Public comment response

January 2, 2026

Re: Project File #608020 Cape Cod Bridges Project

Figure 2 - Location of proposed overpass versus existing path plan

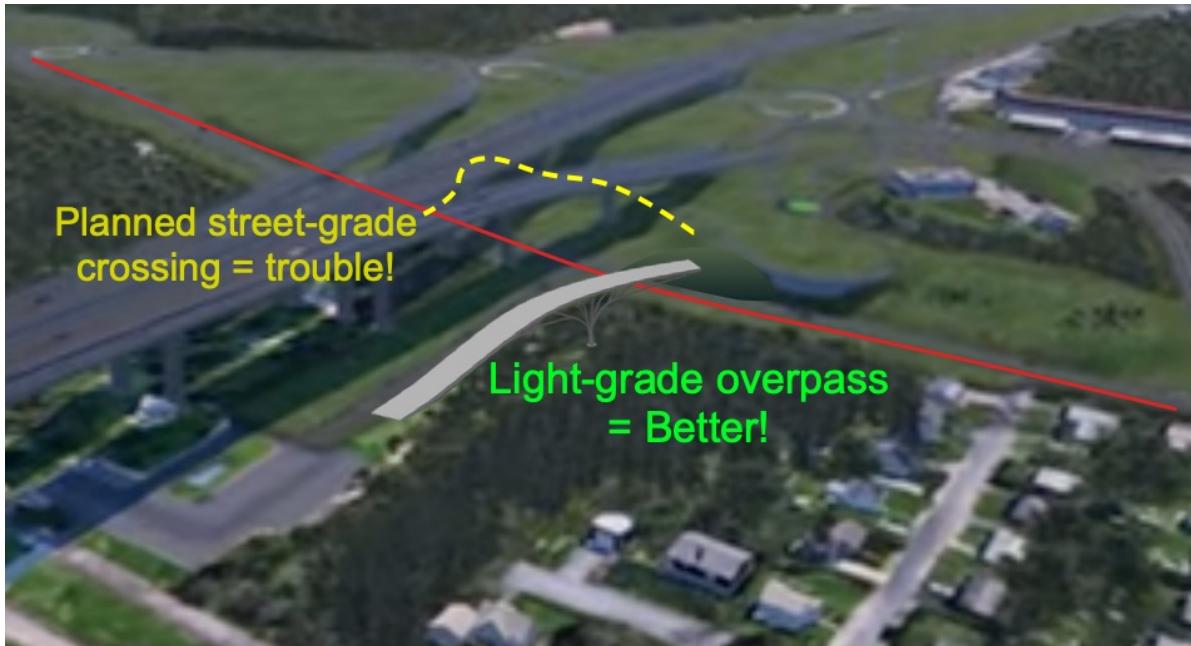
A light, ramped, grade-separated bike & walker overpass is a simple cost-effective solution that **eliminates the issue entirely** by leveraging the existing site elevation, the already-planned retaining wall, and already-available land. Figure 2 illustrates this.

- **Simplifies canal bike path connection.** The overpass can safely exit near most users' destination - the bike path.
- **Eliminates vehicle-human conflict.** Period. The overpass entirely avoids the interaction between bikes & walkers, and eliminates driver interference.

Figure 3 - Descent Ramp into existing public property

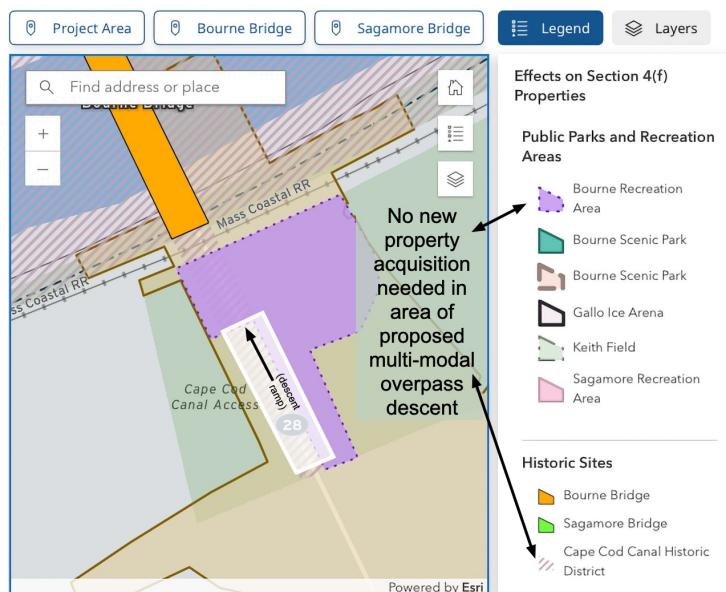
- **The change leverages planned structures.** A structural berm and major path descent are already included in the current plan; these elements can be reworked to form the southerly approach to the overpass. The northerly descent can be accommodated by a light, non-vehicular structure. A preliminary examination by project engineers indicates that replacing the planned path with an overpass is feasible.²
- **No new property required.** The northern side of the overpass, which constitutes the descent over grade, can descend into the existing Bourne Recreation Area and Cape Cod Canal District property. No property taking is required. See rough placement illustrated in Figures 3 & 4.
